FROM STA. 40+39	TO STA. 40+94.50
PROJECT NAME	MONTPELIER
NO. M66C-M6400 (7)	PLOTTED 05/04/87
SURVEYED BY	KASTNER-MOREAU 06/85
SHEET 202 OF 335	SHEETS

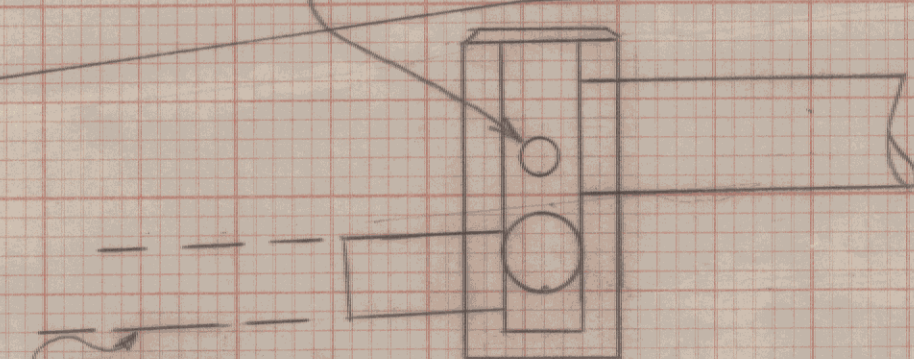
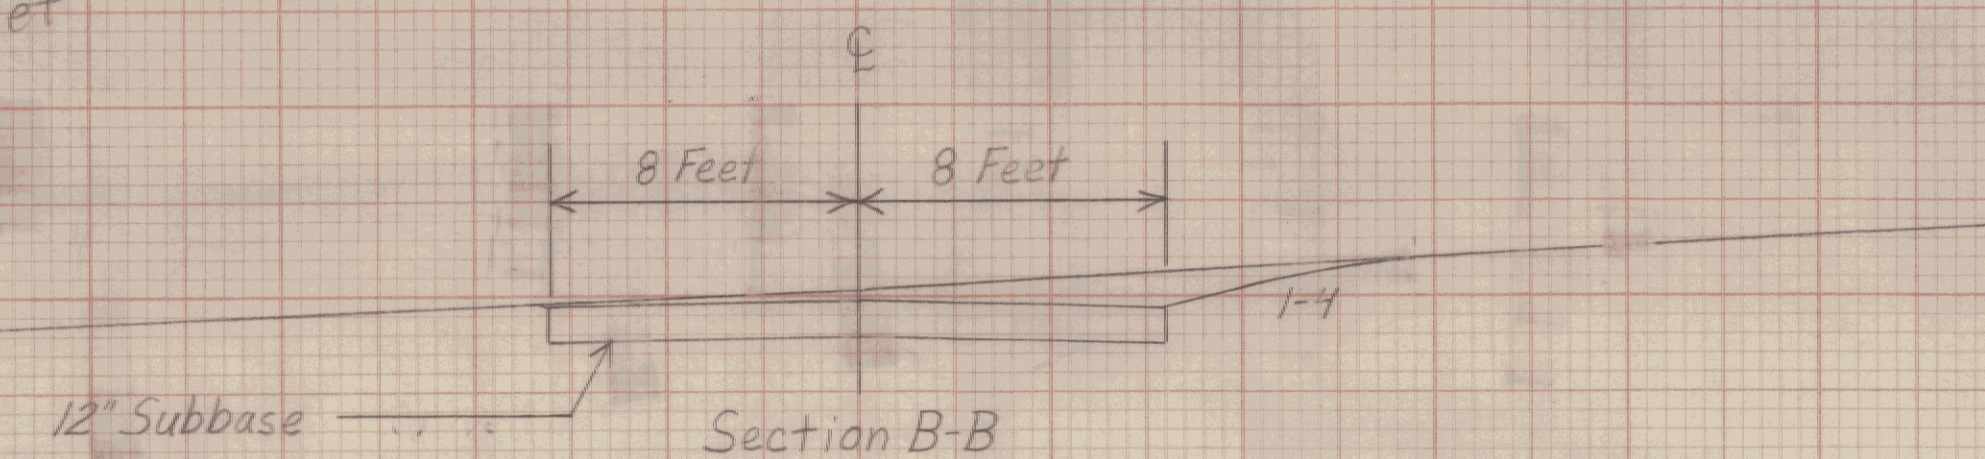
Rev 40+98L
End Portland Cement Concrete Sidewalk, 5' 5" wide

Rev 40+95L ~ Wheelock St. 25+59L.
Exist. 12" CSP and DI - Retain Change Elev. of DI.

Rev. 40+95L ~ 41+84L
New 24" x 94" PCCSP .064 or CAAP .060

Rev. 40+95L
New 24" x 4" CSP .064

Rev. 40+97L
Construct Sidewalk Ramp (Type I)

Rev 40+90L
End Vertical Granite Curb

Rev 40+50L
End New 18" x 160" PCCSP .064 or CAAP .060

Rev. 40+48L
Begin Vertical Granite Curb

Rev. 40+39L
Construct Drive 16' Wide (Paved)

Rev. 40+26L
End Vertical Granite Curb

Rev. 40+50L ~ Rev. 40+67R
New 18" x 34" PCCSP .064 or CAAP .060

Rev. 40+90R
End New 6" x 330" Underdrain w/ Flushing Basin @ 40+90R
Rev. 40+62R
Begin Vertical Granite Curb

Rev. 40+55R
Construct Drive 16' Wide (Gravel)

Rev. 40+46R
End Vertical Granite Curb
